RE: **Recall Campaign 2017090002**
Launch Notification
MY17 453 (smart) Steering Knuckle

Campaign No. 2017090002, September 2017

SUBJECT: **Model 453 Model Years 2017**
Check left front axle steering knuckle and replace, if necessary

**Figure 1**

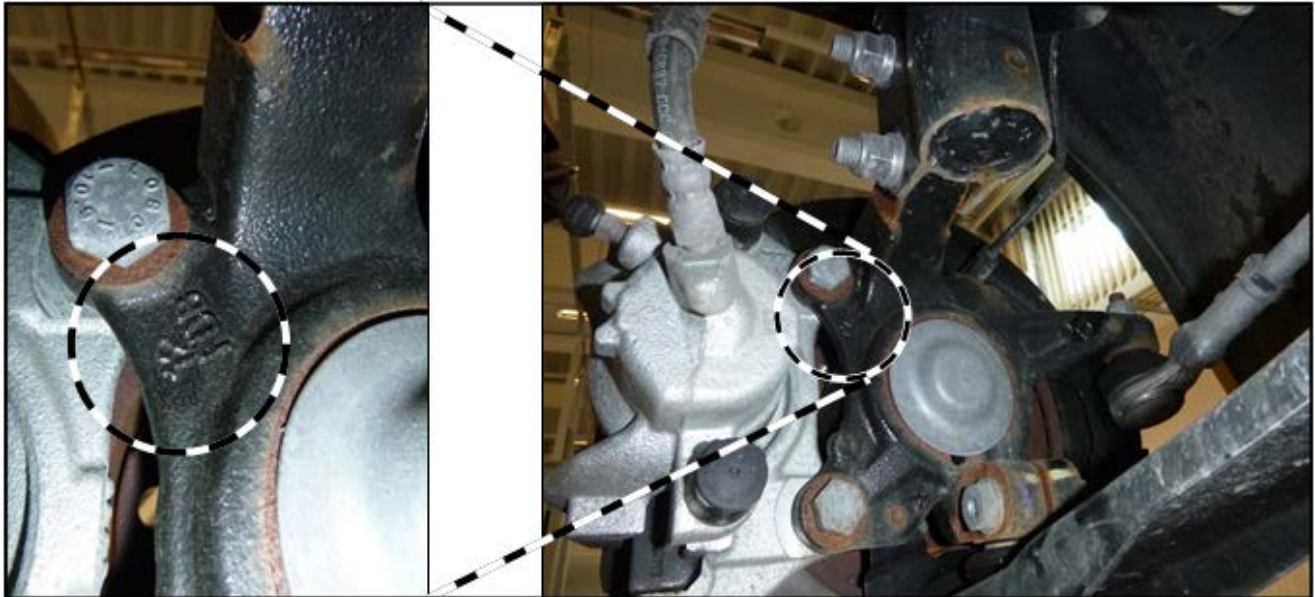
1. Lift vehicle with vehicle lift.
2. Check outer steering knuckle stamping (**figure 1**)

- a) If "FDB 14" is stamped on the steering knuckle: Perform check B
- b) If another stamping is present: End measure
